June 8, 2012

**Re: City of Warrenton (00932) DeLaura Beach Waterline Project
 Conditional Approval for PR #90-2012**

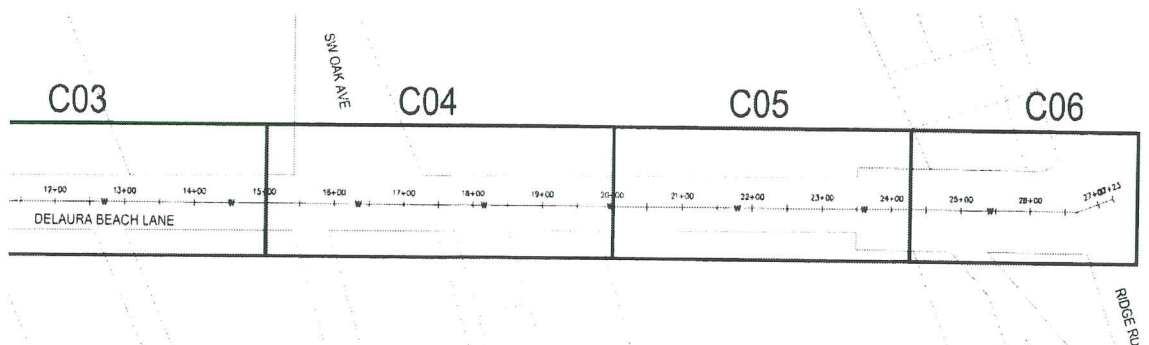
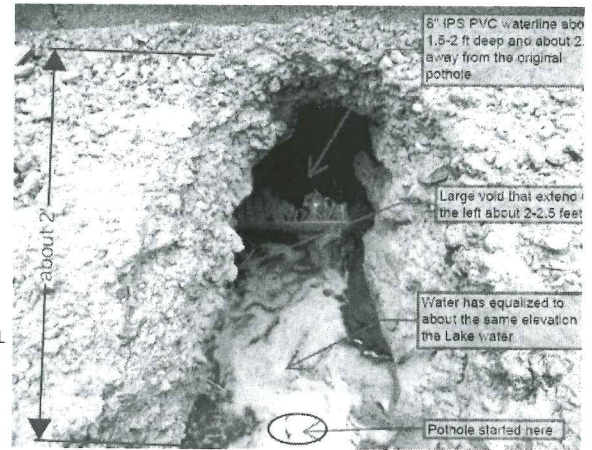
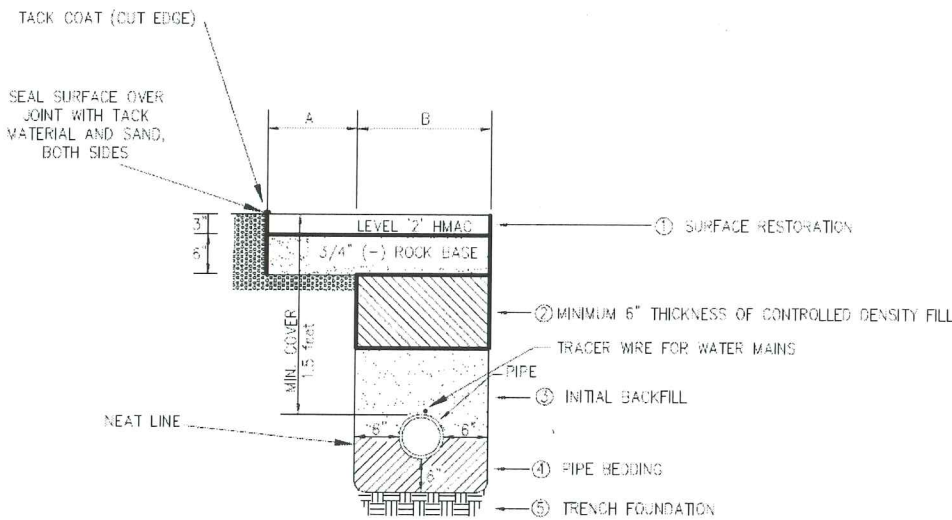
On June 4, 2012 our office received a request to waive the 30” minimum waterline cover required under OAR 333-061-0050(8)(f) for some sections (~ Sta. 12+50 and 19+66) of new 12” dia. C900 waterline to be installed under DeLaura Beach Lane in Warrenton Oregon as shown below:

The construction waiver is granted based on the photographic evidence and log borings showing pervious sand and very high groundwater in the area and the modified trench detail show above **provided blue underground warning tape (either detectable or non-detectable) indicating “Buried Waterline Below” is placed in the trench on top of the pipe wherever the pipe cover is less than 30 inches. The placement of the warning tape is required in addition to the copper tracer wire. Should coliform bacteria or unusual water loss be detected in this part of the distribution system, the City should investigate this section of pipe as a possible source of contamination or leaks. Enclosed is a copy of the approved waiver request form.**
